— ENGINEERING ORDER —

| LOCATION: <u>LOGS CO., SR 28, Jct SR 41</u> | CENTRAL OFFICE ENGINEERING | | DIVISION APPROVAL |

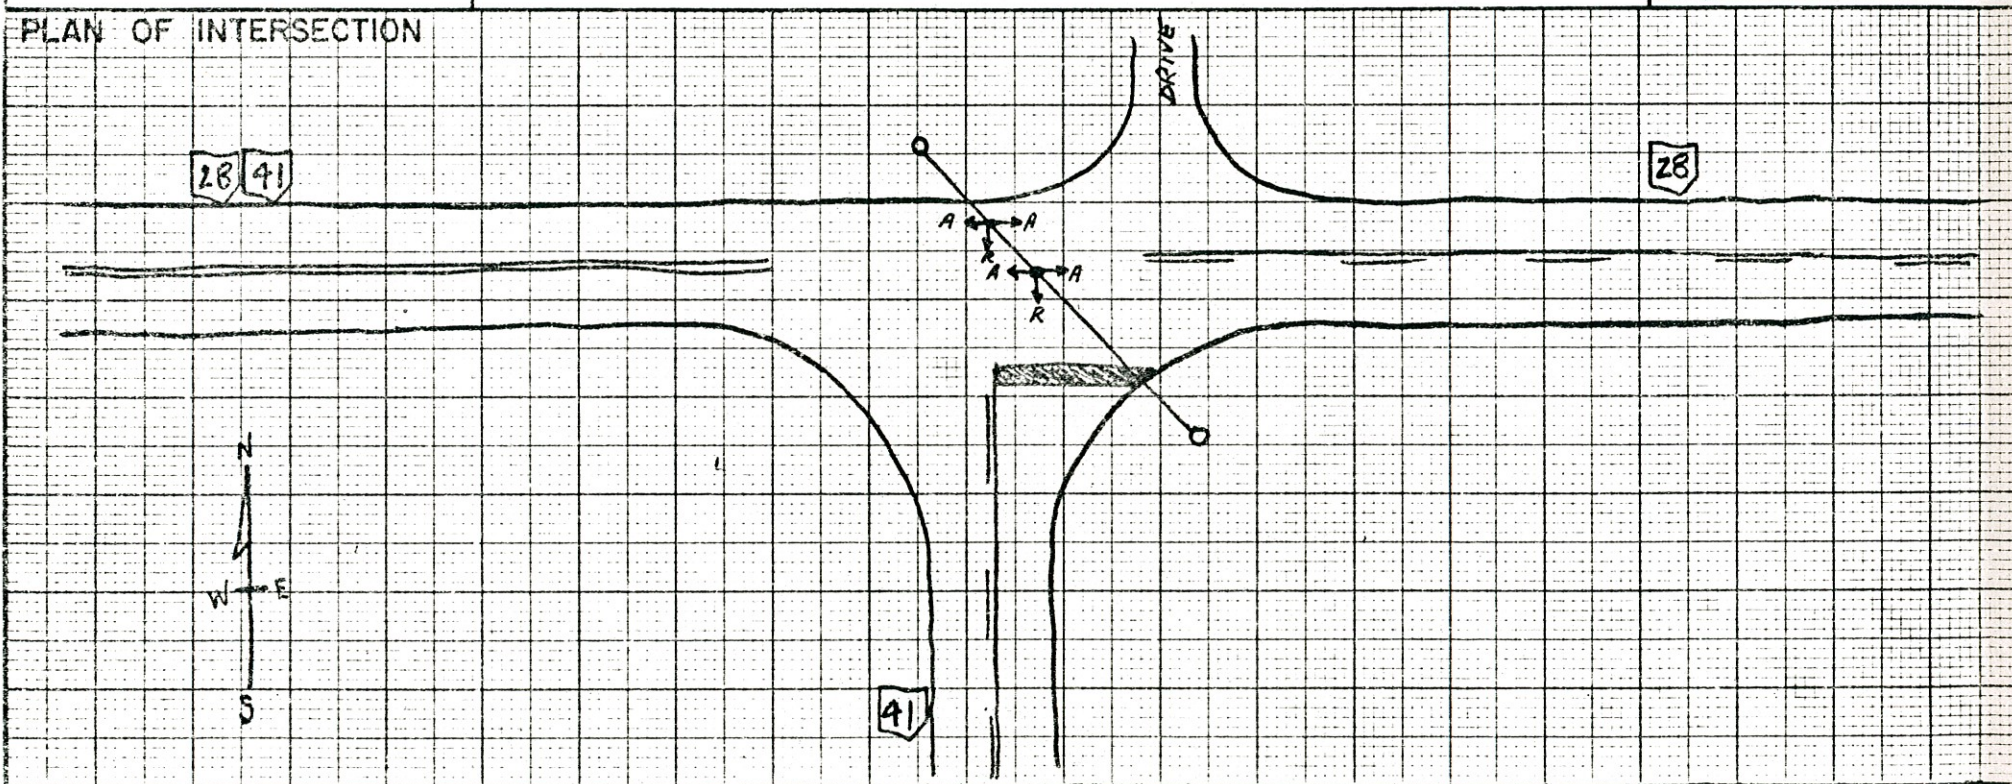
TRAFFIC PROBLEM HIGH SPEED ON SR 28 THRU INTERSECTION. INTERSECTION NOT PROMINENT AT CREST OF VERTICAL CURVE FROM ALL APPROACHES. SR 28 FROM SR 41 DOES NOT LOOK LIKE AN INTERSECTION OR A STOP CONDITION DESPITE ADVANCE SIGNS AND DUAL STOP SIGNS.

| REMARKS | ITEM INSTALLED | DATE | INSPECTED | DATE | EVALUATION | DATE |
|---------------------------------------------------------------------------------------------|----------------|------|-----------|------|------------|------|
| <u>PROPOSED FLASHER AMBER TO SR 28 FB AND RED TO SR 41 FOR INTERSECTION IDENTIFICATION.</u> | | | | | | |
